Scott Horsley  
Water Resources Consultant  
39 Chestnut Street • Boston, MA 02108 • 508-364-7818

RE: 34 Brush Hill Road, Sherborn, MA

I have been retained by abutters and residents of Sherborn to review the above-referenced project relative to hydrologic and water quality impacts. My clients include Andrew and Michelle Lauterback and Dennis and Vicki Natale.

Figure 2 – Cross Section of Proposed Septic Soil Absorption System and Groundwater Mounding

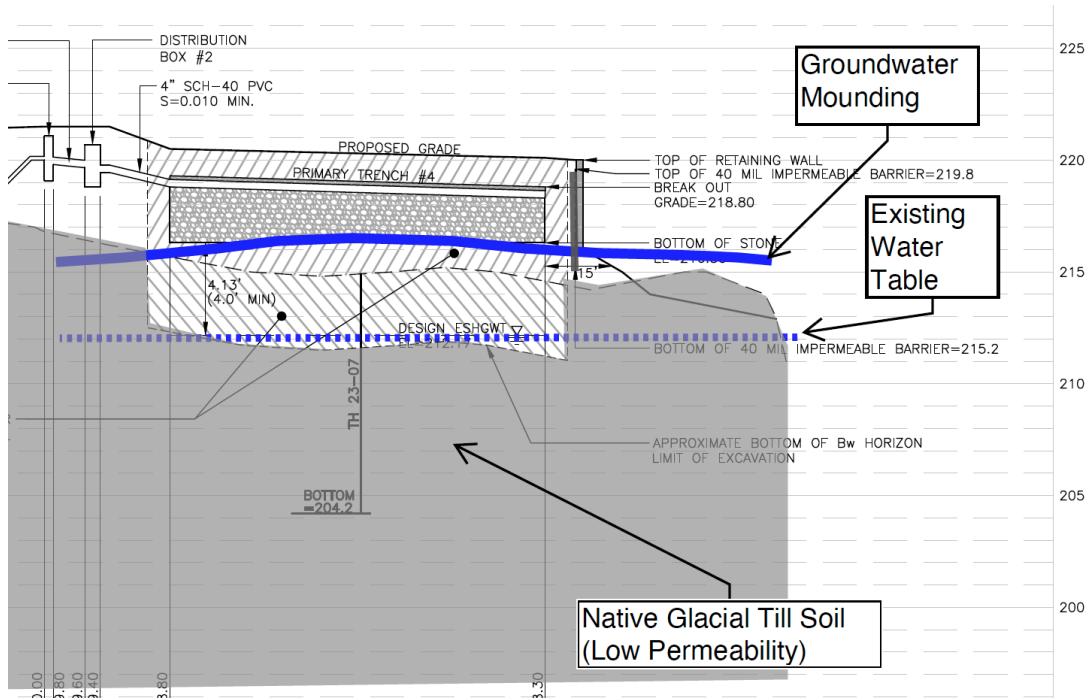
I have conducted a preliminary groundwater mounding analysis using the Hantush model<sup>2</sup>. I have utilized hydraulic conductivity and specific yield values published for this area by the Massachusetts Hydrogeologic Atlas and the dimensions of the soil absorption system and saturated thickness provided by the Applicant (see Appendices to letter). The resulting analysis indicates that the groundwater mounding beneath the system will rise 4.3 feet and will inundate the wastewater soil absorption system (see Figures 2 and 3).

Figure 3 – Hantush Groundwater Mounding Calculations

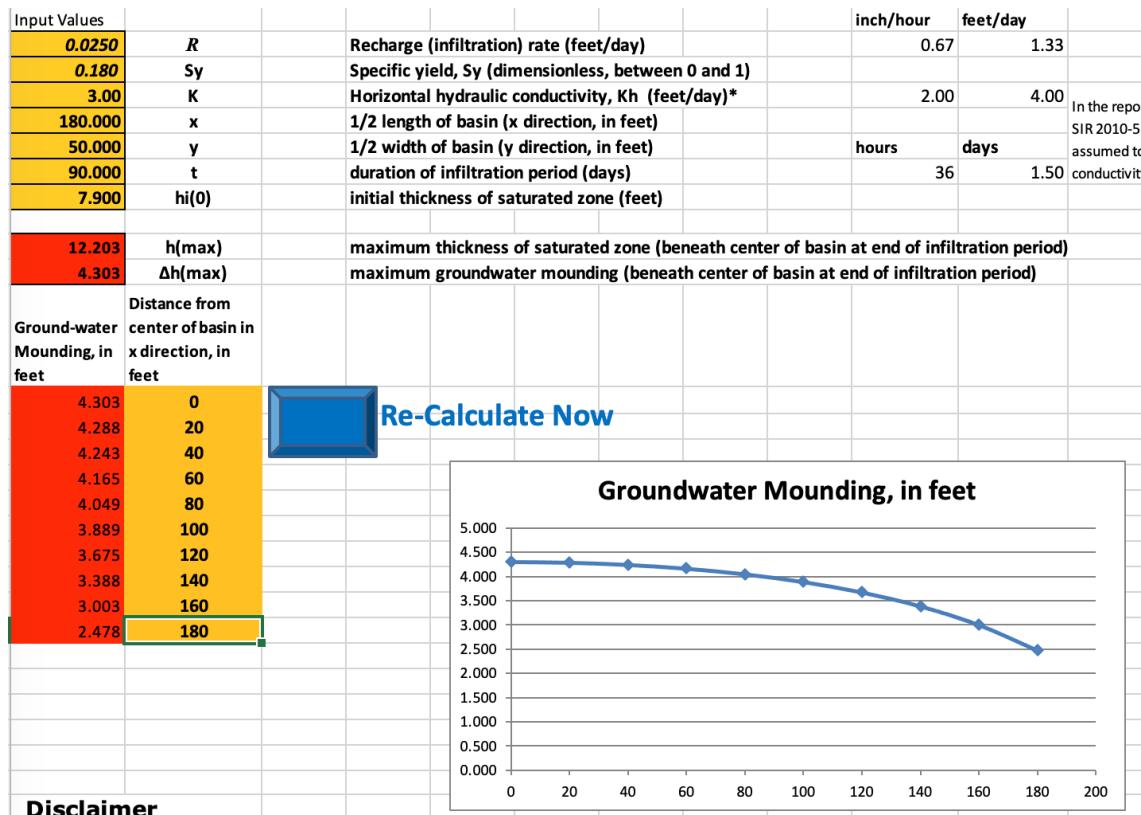
The mounding analysis also indicates significant water table rises of approximately 2.5 feet at distances of 180 feet from the septic system. This mounding will have cumulative impacts on the functioning of the stormwater infiltration systems on the property

Figure 4 – Proposed septic system and surrounding impermeable barrier

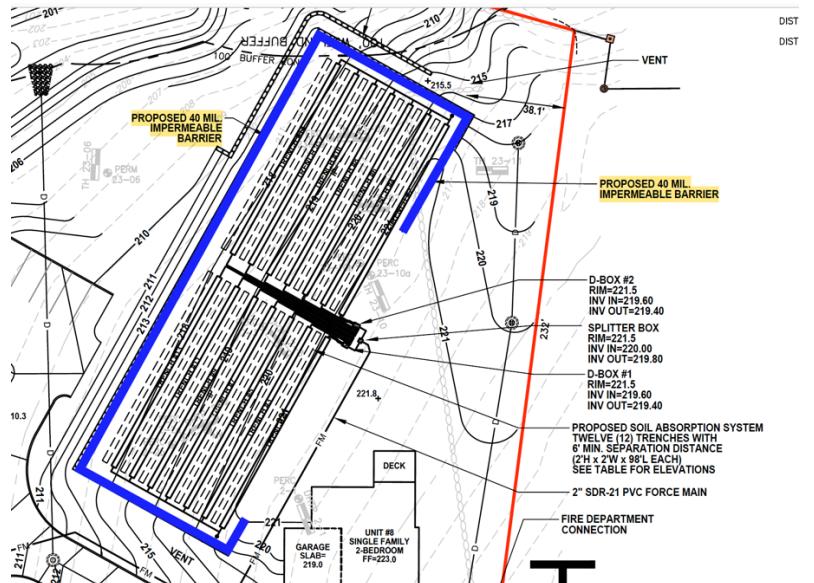
**2. The proposed septic system design includes an “impermeable barrier” surrounding much of its footprint that will constrain the lateral movement of wastewater away from the disposal site and cause it to back up vertically.** Because the project site is not “generally suitable for subsurface sewage disposal<sup>3</sup>” using a conventional design, the proposed project relies upon an artificial impermeable barrier to contain the wastewater (see Figure 4). The proposed barrier will constrain the wastewater discharge and will preclude horizontal dissipation of the effluent (see Figure 5).

The impermeable barrier will cause additional groundwater mounding (beyond what I have modeled using the Hantush model). Additional modeling is required to assess these supplemental mounding conditions caused by the impermeable barrier. This will require an additional model such as MODFLOW that can incorporate boundary conditions (such as the impervious barrier).

Figure 8 – Location of proposed project adjacent to Course Brook (Source USGS StreamStats)

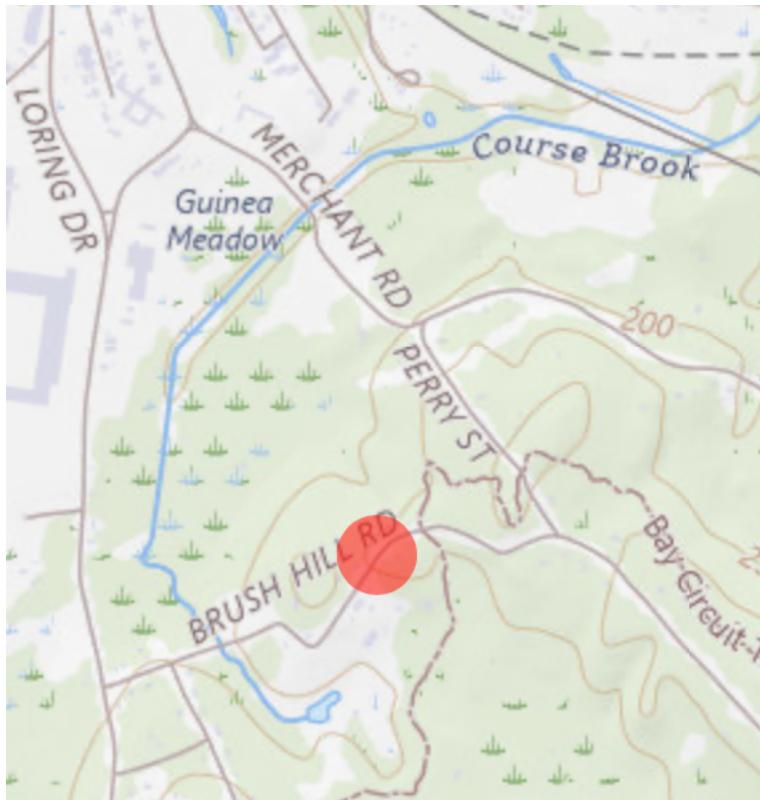
The discharge will contain concentrations of nitrogen of 35 – 100 mg/liter, in excess of and 3.5 – 10 times higher than federal and state drinking water standards (10 mg/liter). It will also discharge an estimated 3 – 6 mg/liter of phosphorus, in excess of and 100 – 200 times higher than surface water quality criteria (0.025 mg/liter). The septic system is surrounded by private drinking water wells and a nearby stream, Course Brook, (to the northwest) and its tributary to the northeast (see Figures 8 and 9).

Figure 7 – Recharger 2 Infiltration System and 100-foot required buffers to private wells

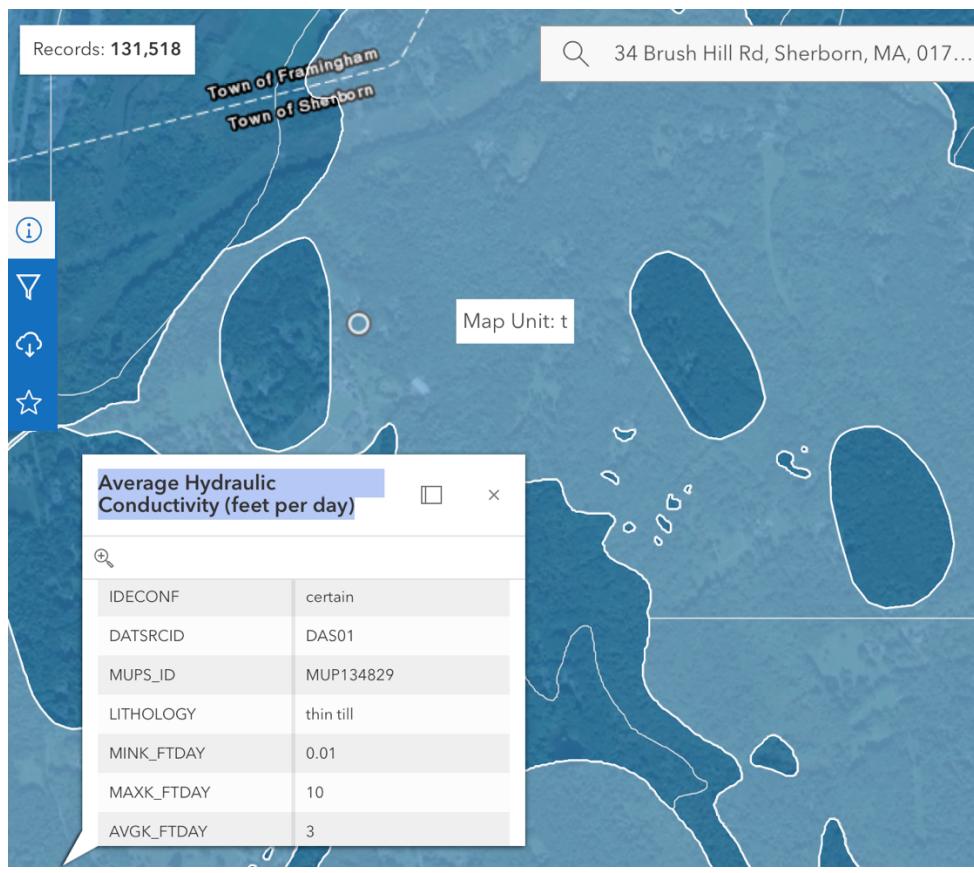
Additionally, the location of stormwater infiltration system "Recharger #2" does not comply with the MADEP Stormwater Standards. The MADEP Stormwater Handbook, Volume 1, Chapter 1, page 8 requires a setback of at least 100 feet between private wells and infiltration systems (see Figure 7). As you can see from Figure 7, "Recharger #2" is within 100 feet of the proposed well locations for Units 4 and 5.
